**Lead Mapping**  
**Travel Centers of America # 39**  
**Hebron, Ohio**  
**PWSID # OH 4544512**

**Lead Mapping In Distribution System**

**Travel Centers Of America #39**

**PWSID # OH 4544512**

TRAVELCENTERS OF AMERICA  
 Figure 2  
 Site Layout Map  
 Hebron TravelCenter #39  
 10878 Hebron Road, SE  
 Hebron, Ohio  
 Project No. 9/78/14  
 Date: 9/78/14  
 Author: J. Shorn

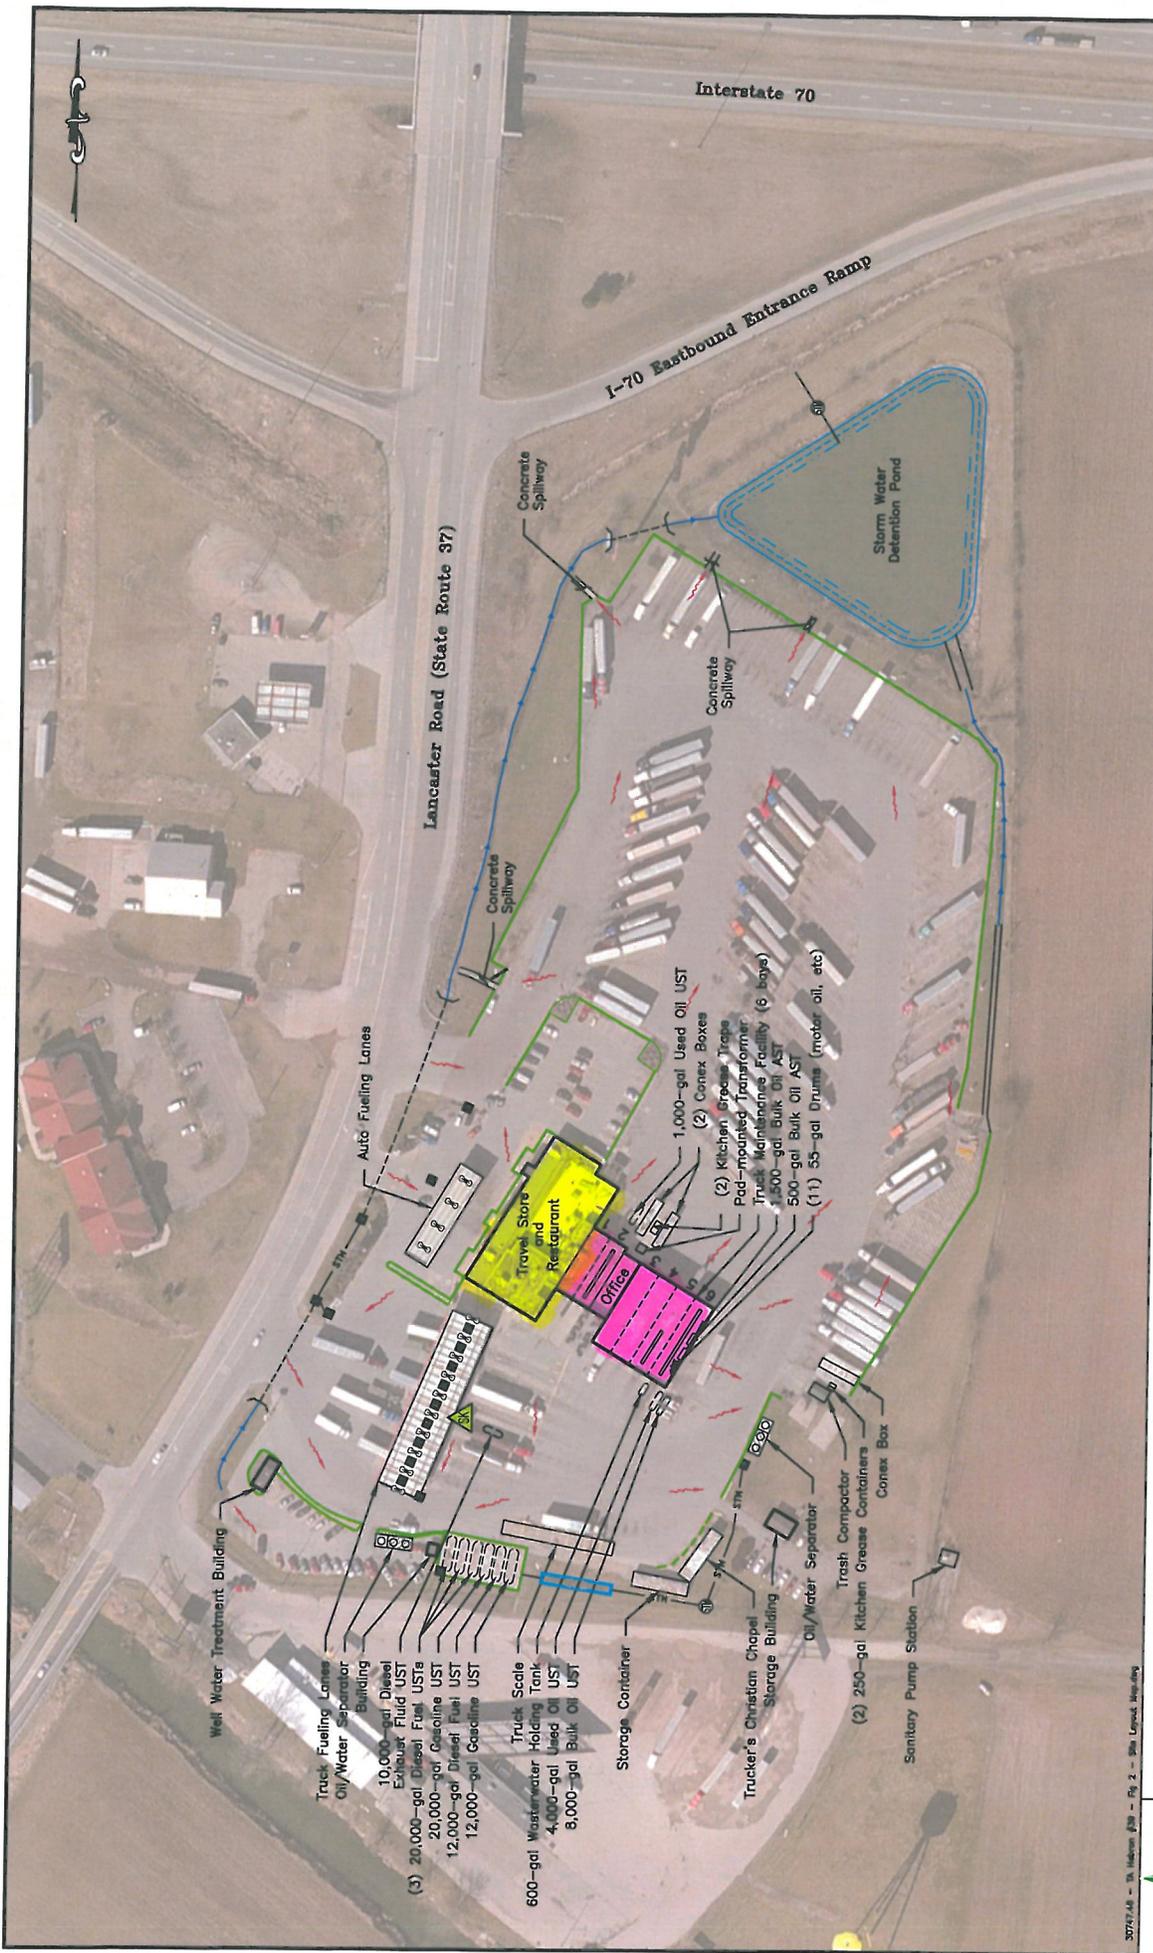
I reviewed the Pb mapping info that you submitted and was received yesterday. One comment that needs to be addressed is that you need to include info on the service line from the well/treatment building to the main buildings/restaurant. It is not shown on the map and there is no statement in the narrative as to what the pipe material is and the date of installation.

At this point, my suggestion is to add a sentence or two to the narrative that specifically addresses both the well and the pipe material from the treatment building to the main buildings, including dates of installation, if known. Then submit this to me as an attachment.

Dan,  
On the first page it specifically says under the heading **Lead service lines** From talking with John Barret maintenance supervisor, he recently conducted an audit and reported back to me that no lead service lines are in the ground or inside of the facility. On the second page it says under **Plumbing solder, fixtures** Travel centers of America # 39 Hebron location, all piping consists of copper, galvanized, and polyethylene 5100 200 psi copper type size plastic. **The line running from the well to the building is copper.** I can specifically point that out on the map and make that statement if you feel it is necessary. I go into surgery Monday for a knee replacement so it would probably be later in the month for a response.
